OLD HAYES SOLAR FARM AND BESS

Reference [Planning Application P25/V1646/FUL](#)

SUBMISSION FROM COLESHILL PARISH COUNCIL

Prepared by the Parish Council and Coleshill Solar Farm Focus Group,

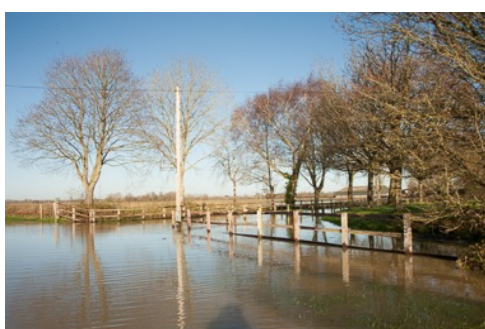
4.12 The proposed development will **exacerbate summer drought effects and low flows in the River Cole**, as well as flooding. Loss of rain to evaporation from the panels is noted but not developed further. Deep summer cracking is a feature of the clay-based soils here and could be worse; this impact is not considered.
